Statement of Modification

SECTION 4.55 (1A) - MODIFICATION APPLICATION to DA Consent DA-596/2019

Address: 82 Bonds Road, Roselands, NSW 2196 / Lot 1 DP 210492

Council: Canterbury-Bankstown Council

FIGURE 4: Modified Façade Design

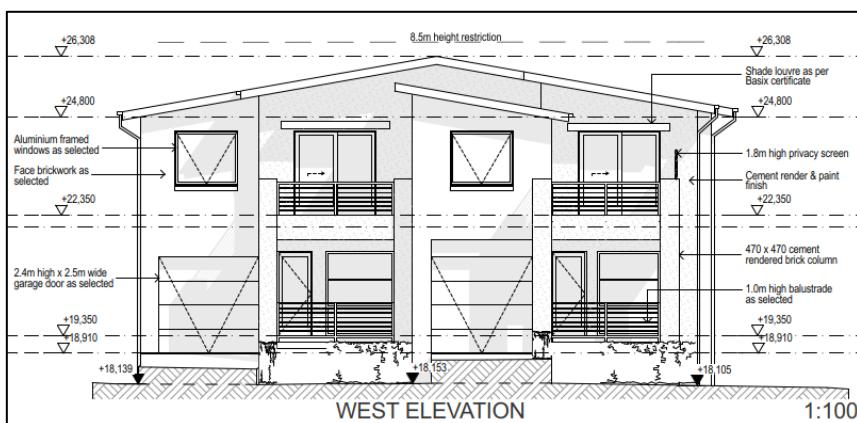
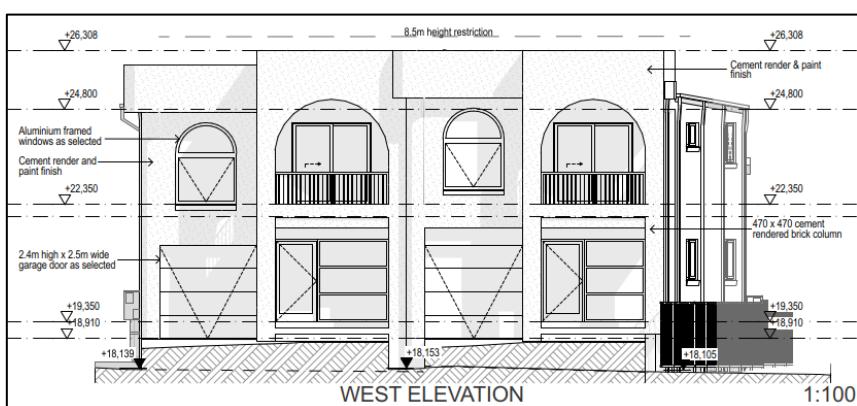
- 1. Alterations to the southern side boundary of Dwelling 2 and associated internal modification to the floor plan – this is to satisfy Sydney Water requirements and Condition 2a of the DA Determination;**
- 2. Removal of Condition 2b of the DA Determination, referencing the submitted Traffic Impact Assessment which determined the approved driveway design to be compliant;**
- 3. Modifications to the façade and associated internal modifications to the floor plan;**

<u>Façade Treatment</u>	<p>The proposed modifications to the façade will use non-reflective cement render and paint finishes with a coordinated colour palette that will present as a harmonious assortment of detail and treatment.</p> <p>The front balconies and fenestrations will have adequate sun shading devices which are incorporated into the architectural design.</p> <p>The façade will not include vast expanses of unarticulated sections.</p>					
<p>C15 Use non-reflective materials, do not randomly mix light and dark coloured bricks, and treat publicly accessible wall surfaces with anti-graffiti coating.</p> <p>C16 Façade design should reflect the orientation of the site using elements such as sun shading devices, light shelves and bay windows.</p> <p>C17 Facades visible from the street should be designed as a series of articulating panels or elements.</p> <p>C18 The width of articulating panels should be consistent with the scale and rhythm characteristic of bungalows.</p> <p>C19 The width of articulating panels shall be in accordance with the numerical requirements below:</p> <table border="1" data-bbox="477 1057 1049 1102"><thead><tr><th>Facade</th><th>Street Elevation</th><th>Side Elevation</th></tr></thead><tbody><tr><td>Width of articulating panels</td><td>4m to 6m</td><td>10m to 15m</td></tr></tbody></table> <p>Table C2.3: Width of articulating panels</p> <p>C20 Avoid long flat walls along street frontages - stagger the wall alignment with a step (not a fin wall or other protruding feature) of at least 0.5m for residential buildings.</p> <p>C21 Vary the height of modules so they are not read as a continuous line on any one street between 2 - 4 storeys, step-back to the middle component and again at the top.</p> <p>C22 Incorporate contrasting elements in the facade - use a harmonious range of high quality materials, finishes and detailing.</p> <p>C23 Screen prominent corners with awnings, balconies, terraces or verandas that project at least 1 m from the general wall alignment.</p>	Facade	Street Elevation	Side Elevation	Width of articulating panels	4m to 6m	10m to 15m
Facade	Street Elevation	Side Elevation				
Width of articulating panels	4m to 6m	10m to 15m
